EQUIPMENT UPDATE

Log Number: EU-08-395

Models Affected: P/N 00770.00: MOST CMA DOOR TYPE MODELS
P/N 13607.00: CMA-180 AND CMA-180 TALL MODELS
P/N 13463.10: L-1X, L-1X16, GL-X, GL-C, GW-100

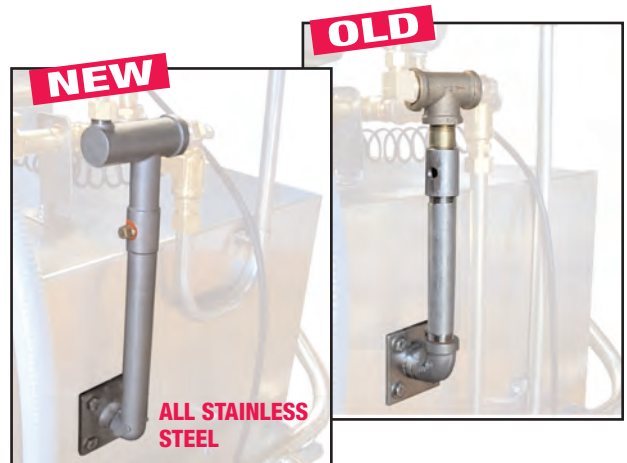
WATER INLET P/N 00770.00
APPLICATION: Models AH/B/C
CMA invested in tooling to cast the water inlet assembly out of stainless steel, thereby eliminating three potential leak connections.

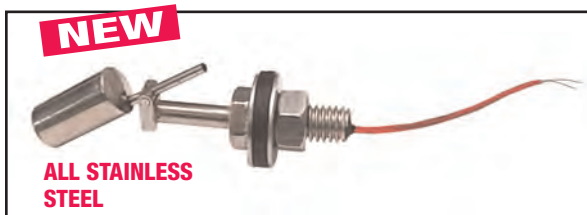
WATER INLET P/N 13607.00
APPLICATION: Models CMA-180
CMA invested in tooling to cast the water inlet assembly out of stainless steel. Six components were reduced to one, thereby eliminating four potential leak connections.
